TR-121092

U.S. OIL & REFINING CO.

June 15, 2012

RE: U.S. Oil & Refining Co.: Rule Exemption Request, Chapter WAC 480-60

US Oil dwg. # SD07201-S10.06
Safer Harbor dwg. #12-128 Rev. 3

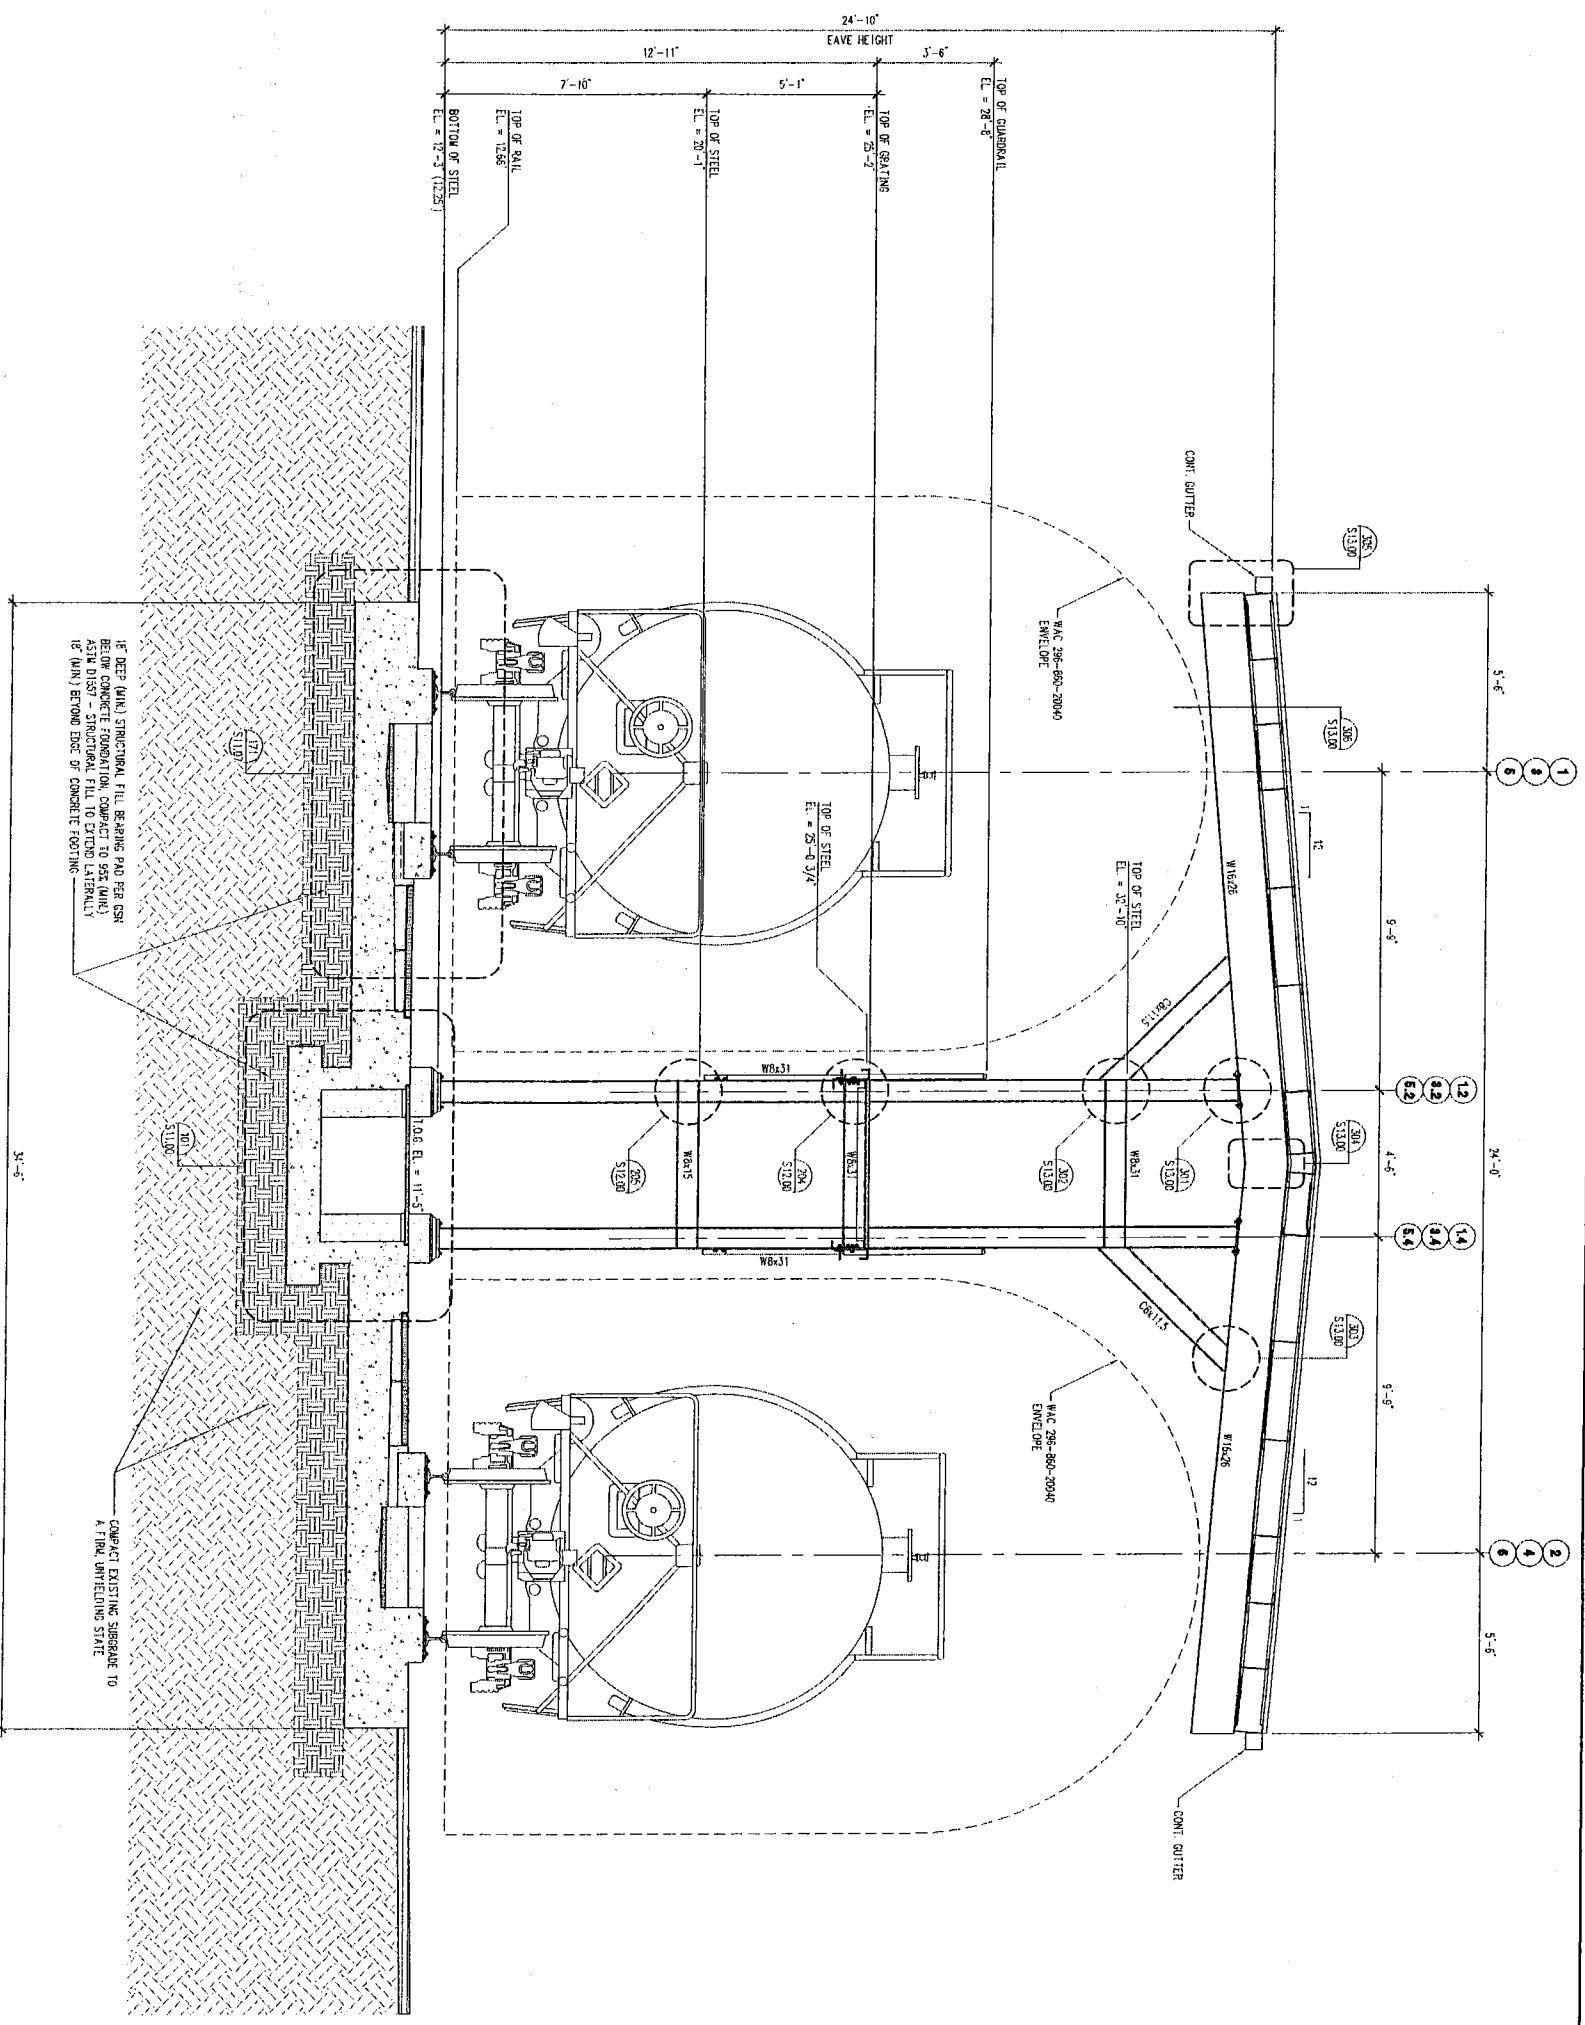
- The minimum overhead clearance attained by the USOR proposed design is less than that required by WAC 480-60-040 with the safety cage being 18'-5" above the top of rail in the stowed position. See attached drawing #12-128.

- The minimum side clearance attained by the USOR proposed design meets the criteria required by WAC 480-60-050 for icing platforms. The safety cage in the stowed position has the 7'-3" side clearance for platforms from the track centerline. See attached drawing #12-128.

- 3) Although the proposed retractable platforms infringe on the overhead prescribed by WAC 480-60, the attached exhibit demonstrates that the fully stowed retractable platforms allow for ample clearance of a tank car ("Plate C" Envelope) and a locomotive (Locomotive Envelope).
